RFQ NUMBER
HHR90013

LINE	QUANTITY	UOP	CAT NO	ITEM NUMBER	UNIT PRICE	AMOUNT
0001	1	JB		910-65		
				RENOVATIONS AT MILDRED MITCHELL-BATEMAN HOSPITAL

ADDENDUM NO. 2**PROJECT: Mildred Mitchell-Bateman Hospital Renovations****TO: Prospective Bidders****FROM: Blackwood Associates, Inc., Architect, Fairmont, WV**

VESTIBULE 008A FLOOR PLAN
SCALE: 1/8"=1'-0"

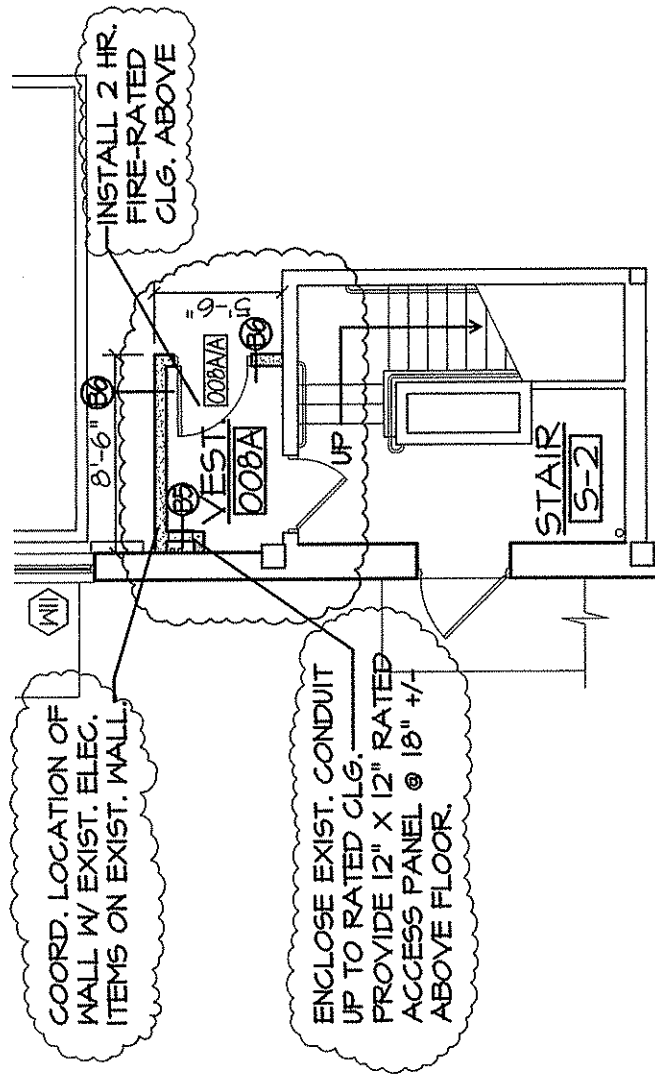
Drawing A101 "Building Two – Basement Floor Plan"**16. ADD** Vestibule No. 008/A as shown on attached Drawing R/A-1.**17. Mech. Room 020**

35. **ADD** Door No. 008A/A as shown on attached Drawing R/A-1.

ADD Vestibule No. 008A as shown on attached Drawing R/A-1.

VESTIBULE 008A

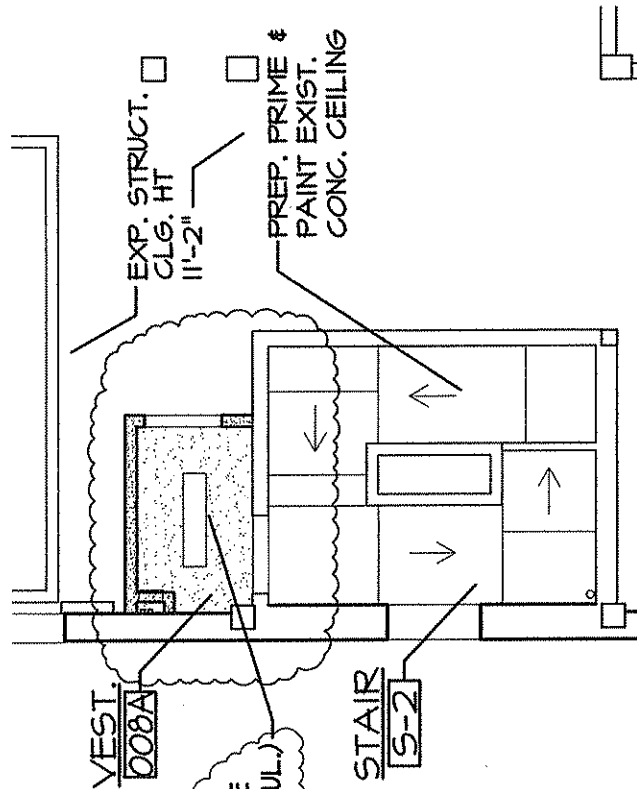
Drawing A106 "Building 2 – Basement Reflected Ceiling Plan"**25. ADD Vestibule No. 008A as shown on attached Drawing R/A-2.****26. Stor. Room 021**

BUILDING TWO - BASEMENT LIGHTING PLAN

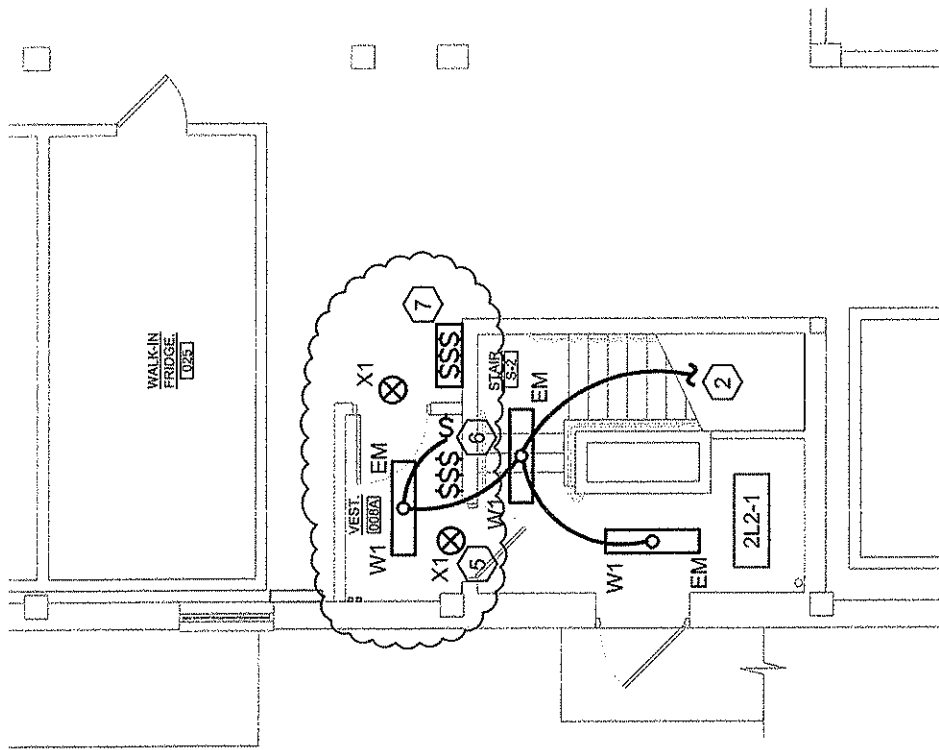
ADD Vestibule 008A Lighting as shown on attached Drawing R/E-1.

BUILDING TWO - BASEMENT
SYSTEMS PLAN

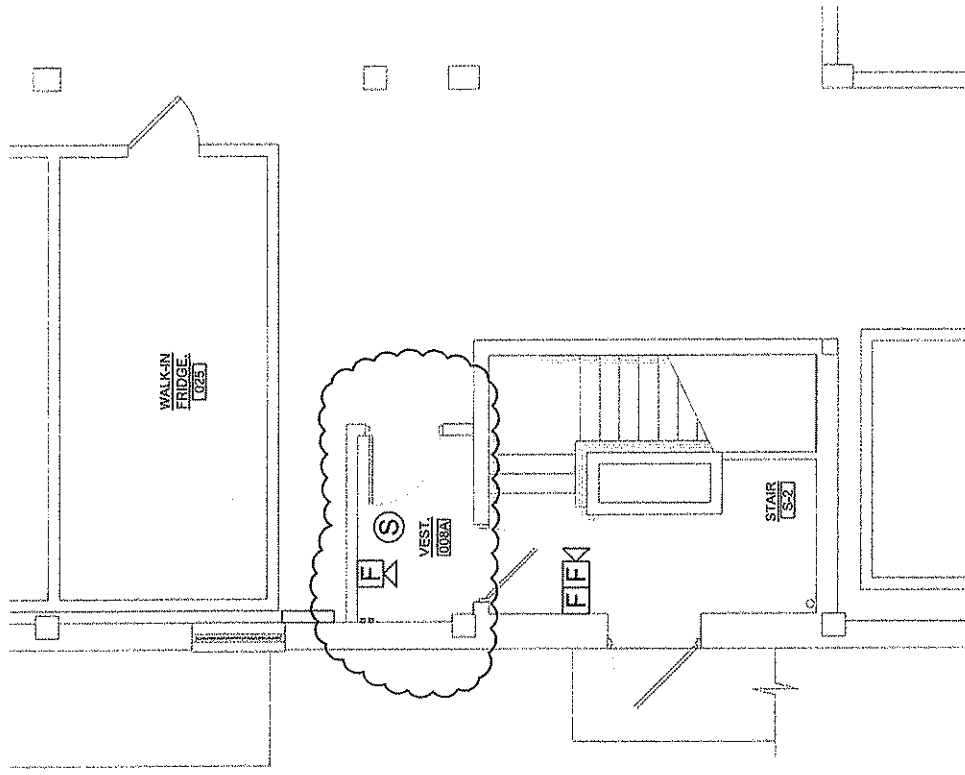
ADD: Vestibule 008A systems equipment as shown on attached Drawing R/E-2.

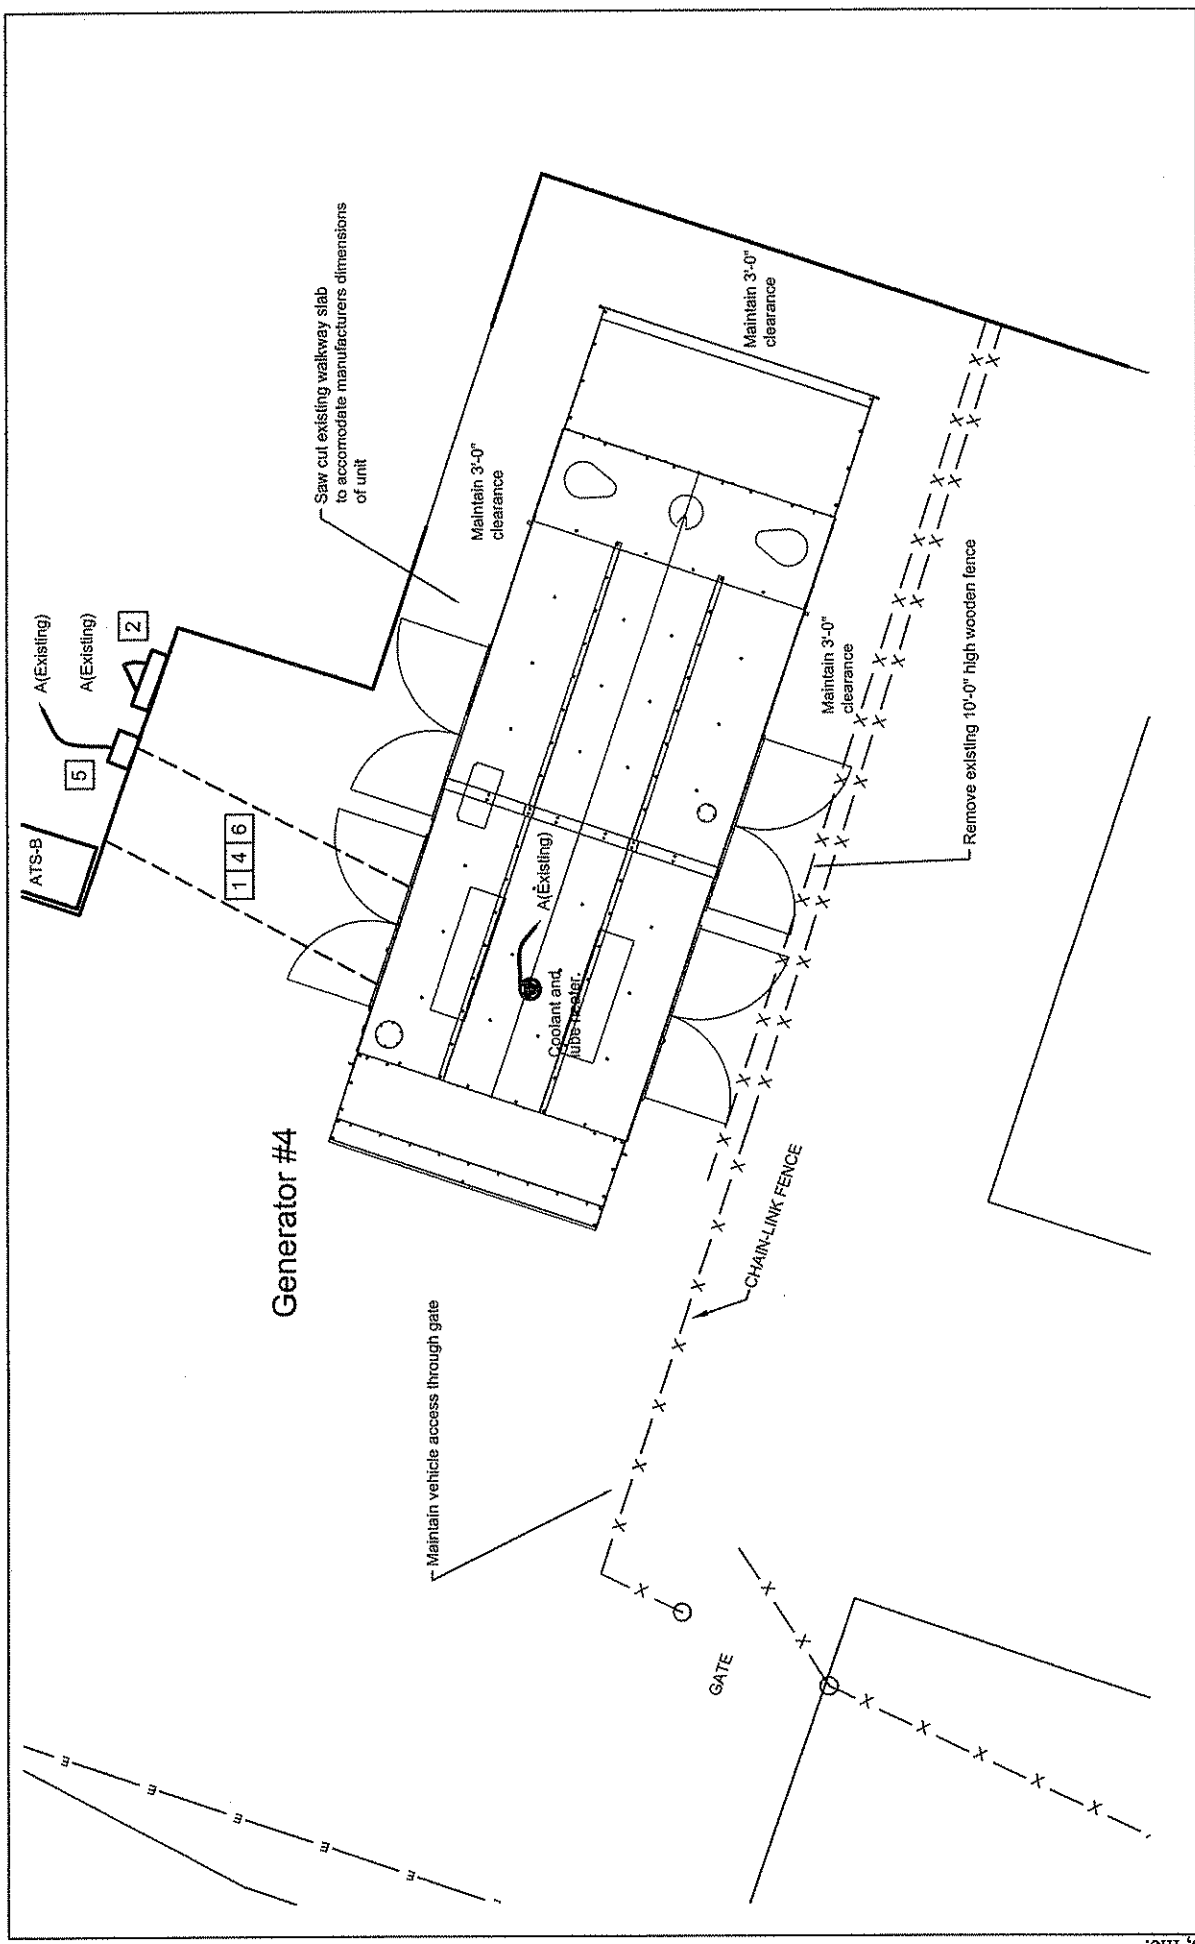
68. Generator Plan Building 4

REVISE: Relocated generator maintaining 3'-0" clearance. Remove existing wooden fence. See attached Drawing R/E-3.
